Notice of Change in IPxx Performance Guarantee Details Due to Correction of Error

· Sealed Vibration Sensors and Tilt Sensor D7E series
< Refer to the " [Details of applicable model] " . >

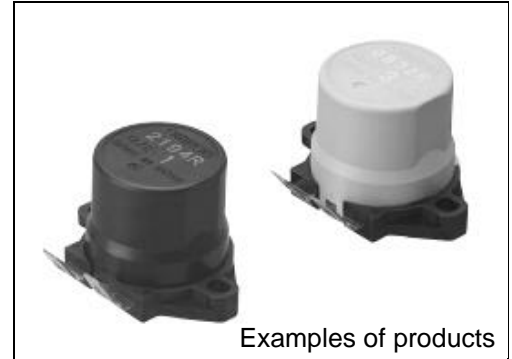
Before the change	After the change																														
<p>The description of performance of degree of protection was incorrectly interpreted as guaranteeing "IP67 (switch section)".</p> <p>● IP67 description in the catalog</p> <p>① Overview</p> <div style="border: 1px solid black; padding: 5px;"> <p>Quickly Detect Vibration or Tilting to Help Prevent Secondary Disasters. Affordable Vibration/Tilt Sensors with Sealed Structure</p> <ul style="list-style-type: none"> • <u>Sealing performance to IP67 degree of protection (switch section).</u> • Applicable to stoves, oil heaters, and other applications that require resistance to harsh environments. • A Tilt Sensor is also provide in the lineup. </div> <p>② Performance</p> <table border="1" style="width: 100%; border-collapse: collapse;"> <tr> <td style="width: 15%;">Model</td> <td style="width: 15%;">D7E-1</td> <td style="width: 15%;">D7E-2</td> <td style="width: 15%;">D7E-5</td> <td style="width: 15%;">D7E-3</td> </tr> <tr> <td>Type</td> <td colspan="3">Vibration Sensors</td> <td>Tilt Sensor</td> </tr> <tr> <td>Degree of protection</td> <td colspan="4"><u>IP67(switch section)</u></td> </tr> </table>	Model	D7E-1	D7E-2	D7E-5	D7E-3	Type	Vibration Sensors			Tilt Sensor	Degree of protection	<u>IP67(switch section)</u>				<p>The description of performance of degree of protection is changed to make it clear that the performance of degree of protection does not guarantee "IP67 (switch section)".</p> <p>● IP67 description in the catalog</p> <p>① Overview</p> <ul style="list-style-type: none"> • Modify and delete descriptions. <div style="border: 1px solid black; padding: 5px;"> <p>Quickly Detect Vibration or Tilting to Help Prevent Secondary Disasters. Affordable Vibration/Tilt Sensors That Take Sealing into Consideration</p> <ul style="list-style-type: none"> • Applicable to stoves, oil heaters, and other applications that require resistance to harsh environments. • A Tilt Sensor is also provide in the lineup. </div> <p>② Performance</p> <ul style="list-style-type: none"> • Delete "IP67(switch section)" from Degree of protection • Add Notes *2 <table border="1" style="width: 100%; border-collapse: collapse;"> <tr> <td style="width: 15%;">Model</td> <td style="width: 15%;">D7E-1</td> <td style="width: 15%;">D7E-2</td> <td style="width: 15%;">D7E-5</td> <td style="width: 15%;">D7E-3</td> </tr> <tr> <td>Type</td> <td colspan="3">Vibration Sensors</td> <td>Tilt Sensor</td> </tr> <tr> <td>Degree of protection</td> <td colspan="4"><u>---*2</u></td> </tr> </table> <div style="border: 2px solid red; padding: 5px; margin-top: 10px;"> <p>*2 The degree of protection confirms that this product has undergone and passed an IP67 test conducted in OMRON's laboratory under controlled conditions, in accordance with the test methods of the following standards. IEC 60529 and JIS C0920 Due to the product structure, this inspection of the degree of protection does not guarantee the product's compliance with IP67.</p> </div>	Model	D7E-1	D7E-2	D7E-5	D7E-3	Type	Vibration Sensors			Tilt Sensor	Degree of protection	<u>---*2</u>

Model	D7E-1	D7E-2	D7E-5	D7E-3																											
Type	Vibration Sensors			Tilt Sensor																											
Degree of protection	<u>IP67(switch section)</u>																														
Model	D7E-1	D7E-2	D7E-5	D7E-3																											
Type	Vibration Sensors			Tilt Sensor																											
Degree of protection	<u>---*2</u>

Before the change	After the change
	<p>③Safety Precautions</p> <ul style="list-style-type: none"> • Add following description. <div style="border: 1px solid red; padding: 5px;"> <ul style="list-style-type: none"> • Do not use underwater or in dusty locations. • Using the Sensor in conditions where it is constantly exposed to moisture or dust, or with moisture or dust adhered to it may result in malfunction. • Sudden changes in temperature may result in moisture entering the interior of the Sensor due to respiratory effects. • The waterproof and dustproof performance of the Sensor may deteriorate depending on the usage environment. • In order to ensure safe use of the Sensor for your desired application, please perform validation of the Sensor's waterproof and dustproof structure in your usage environment. </div>
